IBC — Egress

2015 GROUP A PUBLIC COMMENT AGENDA

SEPTEMBER 30 – OCTOBER 5, 2015
LONG BEACH CONVENTION CENTER
LONG BEACH, CA

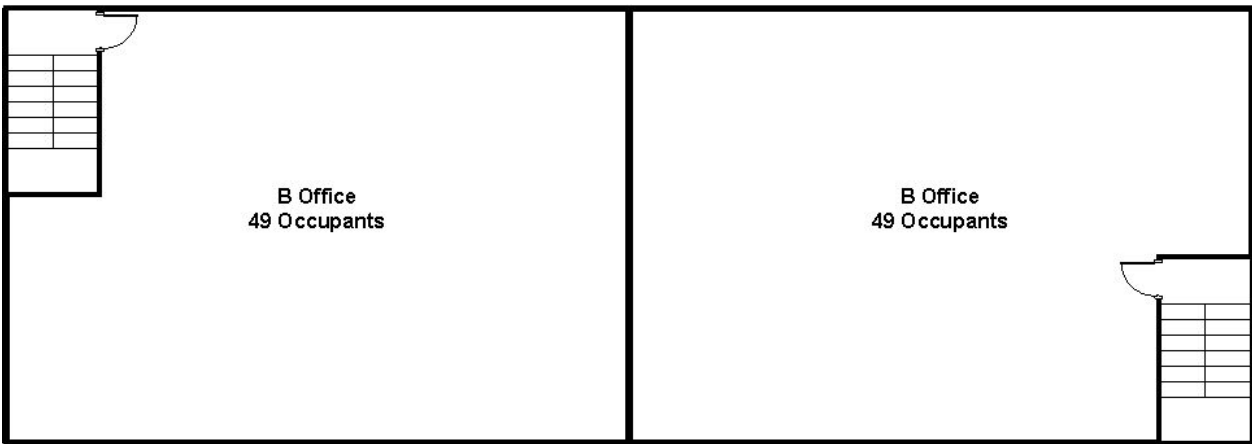
Commenter's Reason: The weakness in the 2015 IBC language is it addresses only the number of exits, or exit accesses, but does not clearly address access to those exits (or exit access stairs, ramps, doors, etc). The public comment clearly requires access to the number of exits required by the section, for each story or occupied roof deck.

This avoids confusion by a plan reviewer when confronted by a proposal (below) where a third story of an office building is renovated to house two tenants, each having 49 occupants and access to one exit, even though the story is provided with two exits. Both the tenant spaces need access to both exits on a third story, The public comment makes that clear.

1006.3 Egress from stories or occupied roofs. The *means of egress* system serving any *story* or occupied roof shall be provided with provide access to the number of exits ~~or access to exits~~ based on the aggregate *occupant load* served in accordance with this section. The *path of egress travel* to an *exit* shall not pass through more than one adjacent *story*. ~~Where a story is required to have two or more exits or access to exits, the rooms, areas, or spaces within that story shall have access to no less than two exits, except as otherwise provided in this code.~~

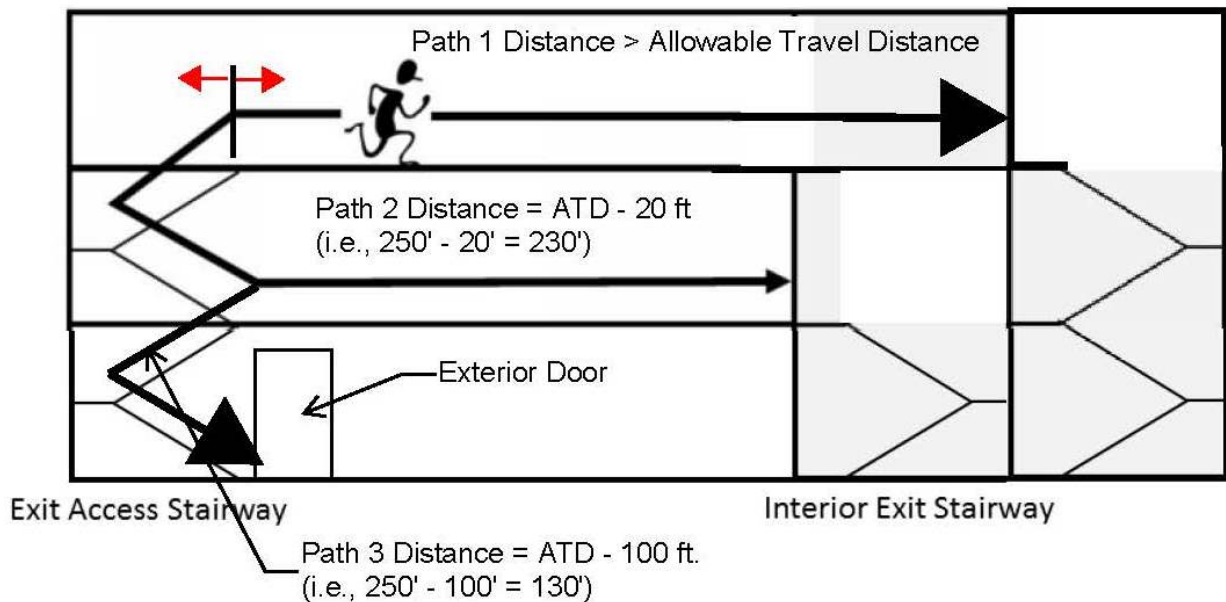
This public comment seeks to add one more exception, one that is tied to a fundamental concept that from the beginning has been associated with the use of an exit access stair - exit access travel distance. From the beginning the CTC Open Stairway Study Group, which developed and brought forth Code Change E5-09/10 resulting in the concept of exit access stairs being an part of a required means of egress system. The Study Group always had the exit access travel distance limits in the IBC at the forefront of the discussions and imbedded in the language that was developed, and accepted by the membership.

In limiting the path of travel to one adjacent story fundamentally ignores the concept of exit access travel distance. What if the exit access travel distance of traversing 2 stories is less than that a person would go on an adjacent story as shown in the

diagram below?

Why should the path of egress not be allowed to go to the closest exit, regardless of the number of stories away from the point of origin? When a person could actually reach an exit located more than one story from where they started in a distance that is less than that if they have to go to the exit on the adjacent story seems so obvious, but without the proposed language the code forces the uses of the exit on the adjacent story, regardless of the travel distance to that exit. This application essentially flies in the face of a fundamental life safety - get people to the closest exit if you can.

We ask that the proposed language to add a new Exception #6 be accepted, thus allowing the exit access travel distance to drive the egress design, not an arbitrary limit of one adjacent story.

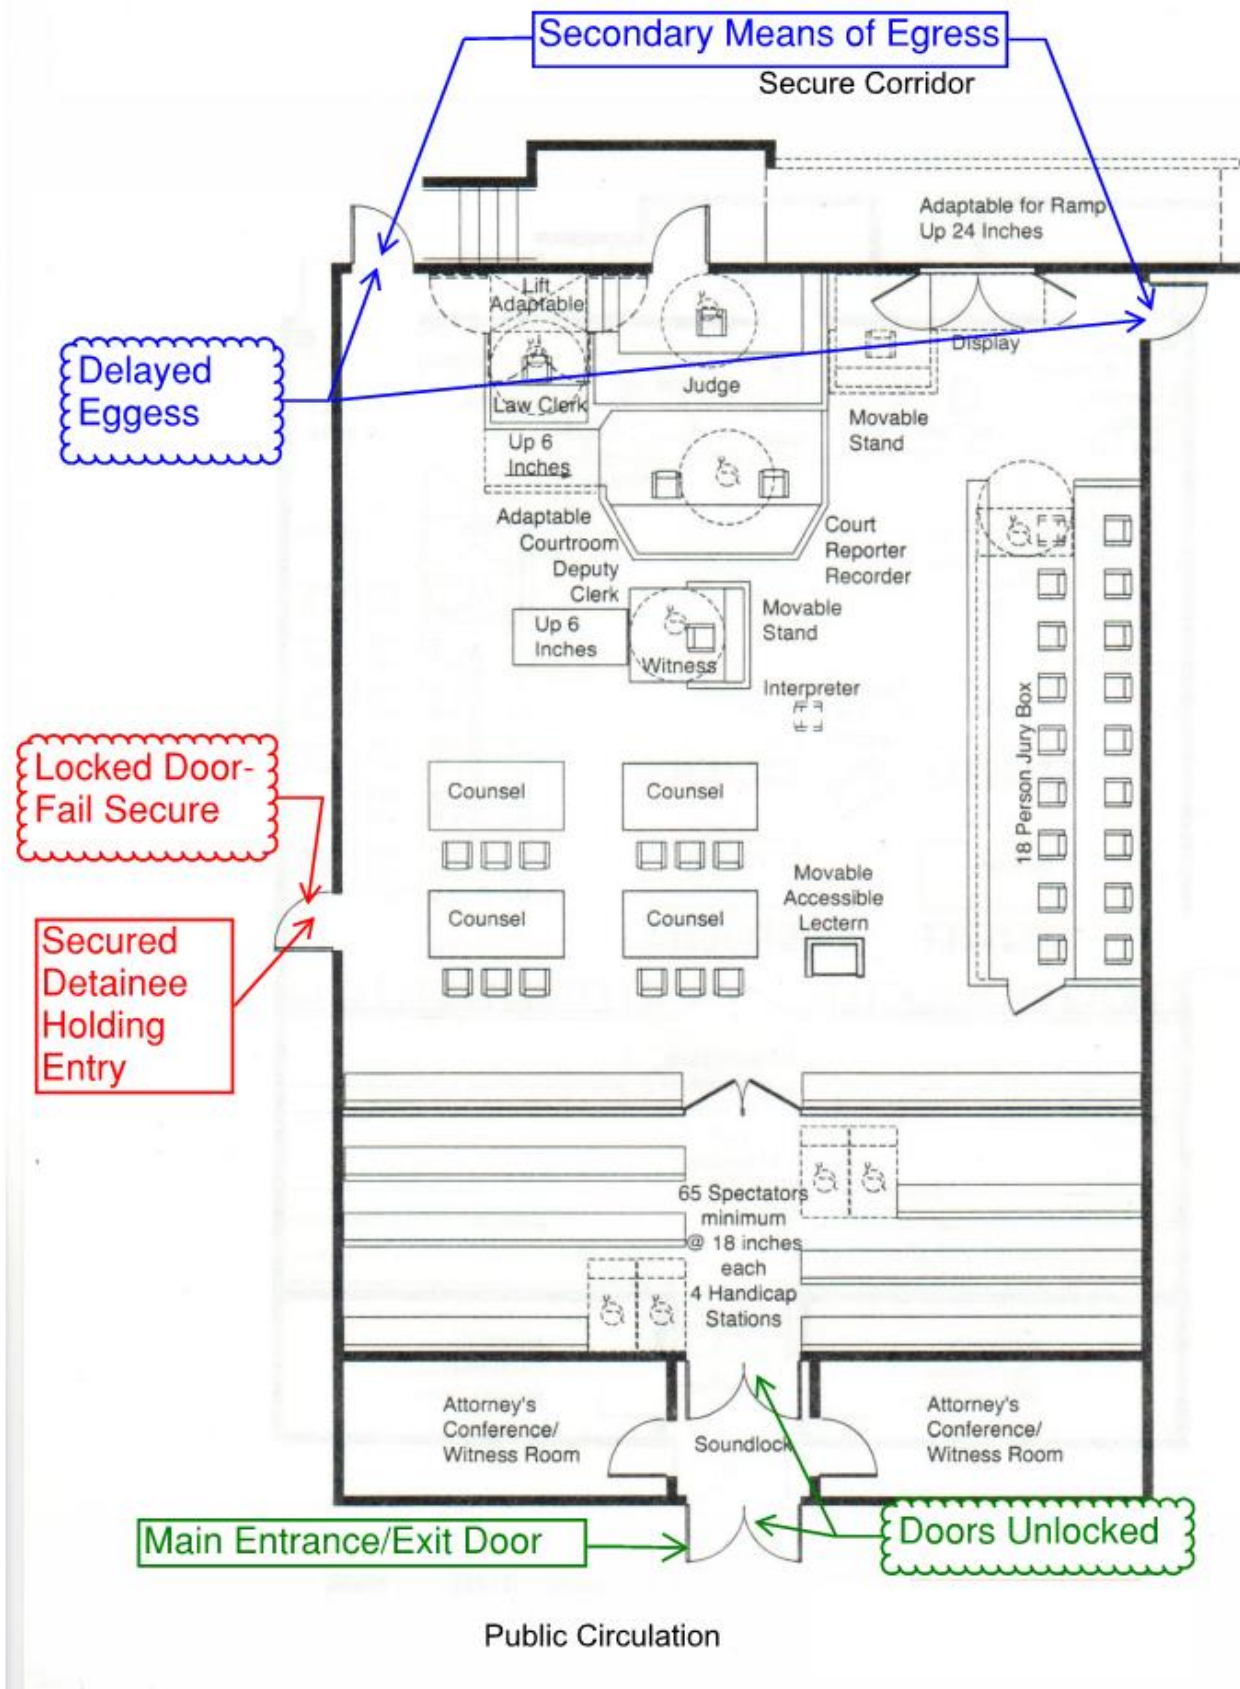
Commenter's Reason: The intent of this code change proposal is to permit the use of delayed egress system on door(s) other than the main entrance/exit door(s) from a courtroom. According to Chapter 3 in the IBC, courtrooms are considered Assembly occupancies. Therefore, delayed egress locking systems would not be permitted to be installed on any doors from a courtroom. However, courtrooms are located within courthouses which are a unique building type that is designed with three separate and distinct circulation systems - one for the public, one for the

judiciary/secure staff, and one for in-custody inmates. The three circulation systems are segregated and they only meet in a single location, the courtrooms. The public enter the courtroom from the public corridor, the judges and court staff enter from the secure corridor and the prisoners enter from the secure detainee area that is typically adjacent to the courtroom. Because each of these groups must be kept separate for security reasons, it is necessary to lock the doors where these groups interface to prevent intermixing.

A standard courtroom design (Please refer to diagram) provides free egress for the public from the main entrance/exit door(s) (the same entrance the public entered the courtroom) to the public circulation area. The door serving the detainee area (prisoner interface) is locked and fail secure, which is permitted by code. As stated above, since the courtrooms are considered an "assembly occupancy" and have an occupant load of 50 or more persons they require a second means of egress.

Fig. A

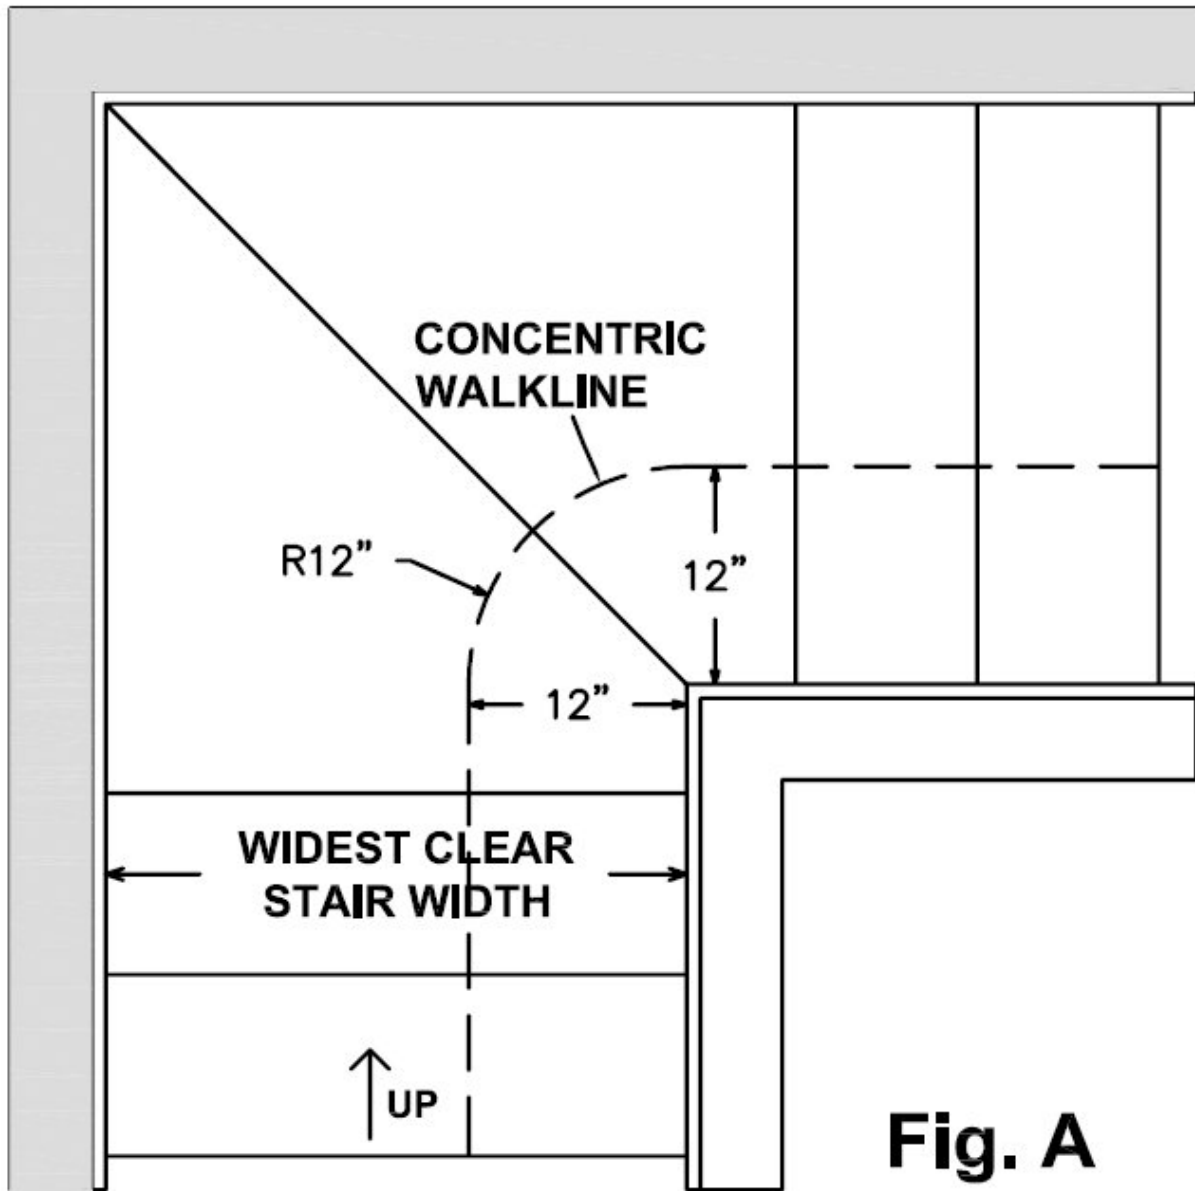
Reason: The current code does not adequately address how the walkline is located where *winders* continue beyond the corner of a turn. (see figure A) A portion of the *winder* treads often extend into the straight segments of the flight where the walkline is not concentric to the turn but parallel to the side of the stairway. This change provides the needed clarification to accurately determine the walkline location.

1011.4 Walkline. The walkline across *winder* treads shall be concentric to the direction of travel through the turn and located 12 inches (305 mm) from the side where the *winders* are narrower. Where the *winders* continue beyond the turn within the straight segments of a flight the walkline shall continue parallel to the side of the stair where the *winders* are narrower. The 12-inch (305 mm) dimension shall be measured from the widest point of the clear *stair* width at the walking surface of the *winder*. Where *winders* are adjacent within the *flight*, the point of the widest clear *stair* width of the adjacent *winders* shall be used.

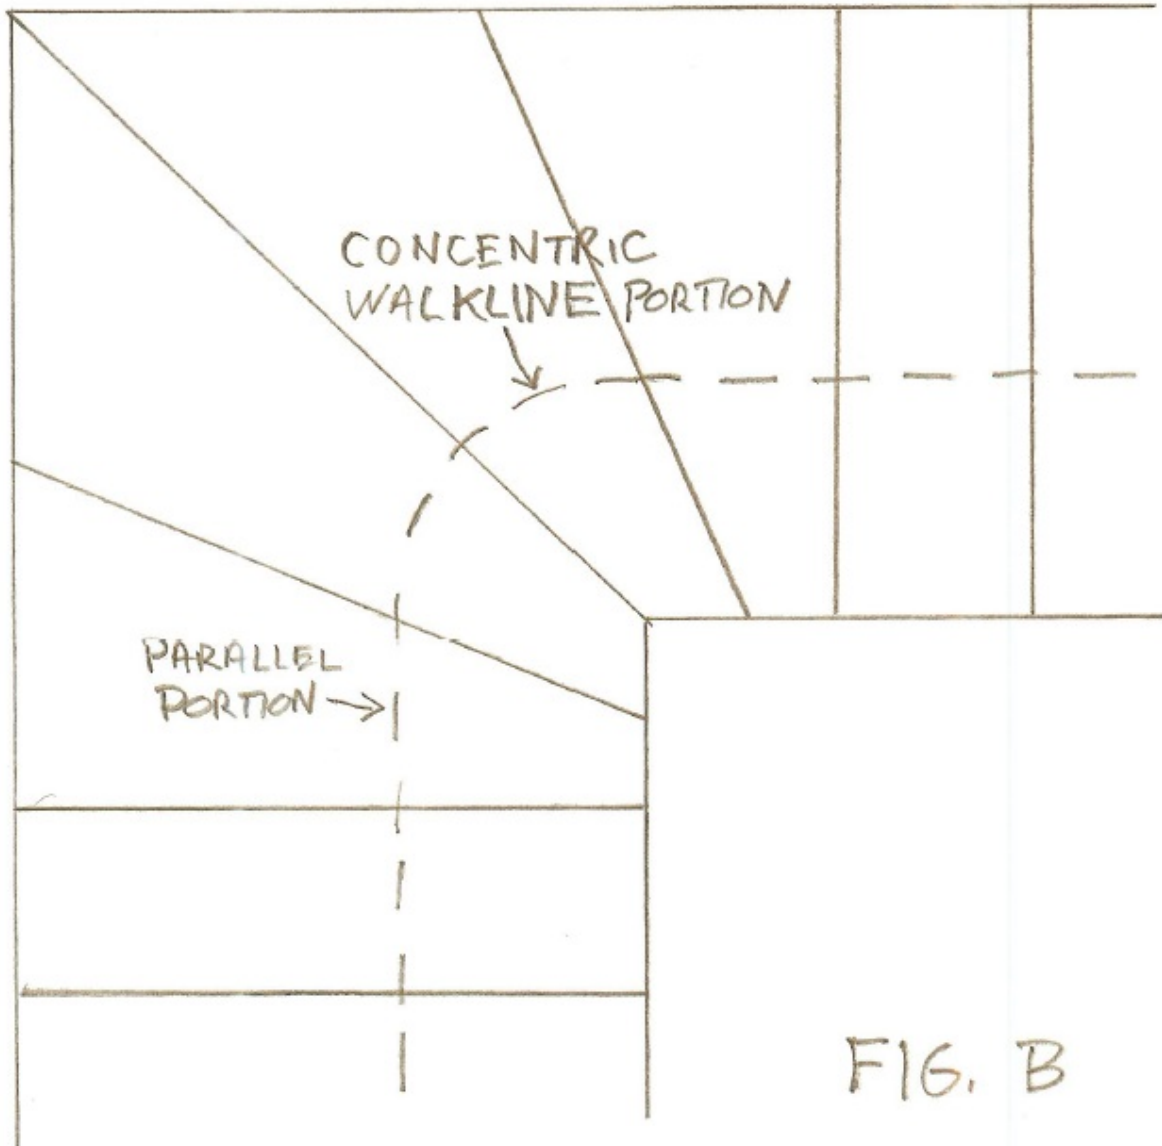
Commenter's Reason: Although we would agree with the committee that the current language in the code suffices for the example given in the original proposal this is simply not the case when the winder layouts are more complicated as shown in **Fig. B**. We would also agree with the committee that the added language in the original proposal was difficult to understand...

... However this modification clearly addresses the committees concerns by eliminating what was considered unnecessary language by the committee and succinctly describing the proponents intent.

This change is needed for several reasons:

1. **As stated in the original proposal**, winder sections of a flight extend beyond the corner. Because winders must have a minimum tread depth of 6 inches (152 mm) at any point, they cannot all meet at the corner but must extend around the corner, beyond the arc of the users turn. This straight extension of the walkline across winders *always occurs*, unless the corner is rounded throughout the turn at great expense, as with curved stairs. **Figure A** shows the most simple arrangement of two winders but winder sections wrapping a corner will have two or more winders with a walkline that is both curved and straight or entirely straight as in the entry and exit winders of **Figure B**. The current code does not accurately describe how the walkline should be demarcated to measure the winder tread depth. The modification provides the needed correction.
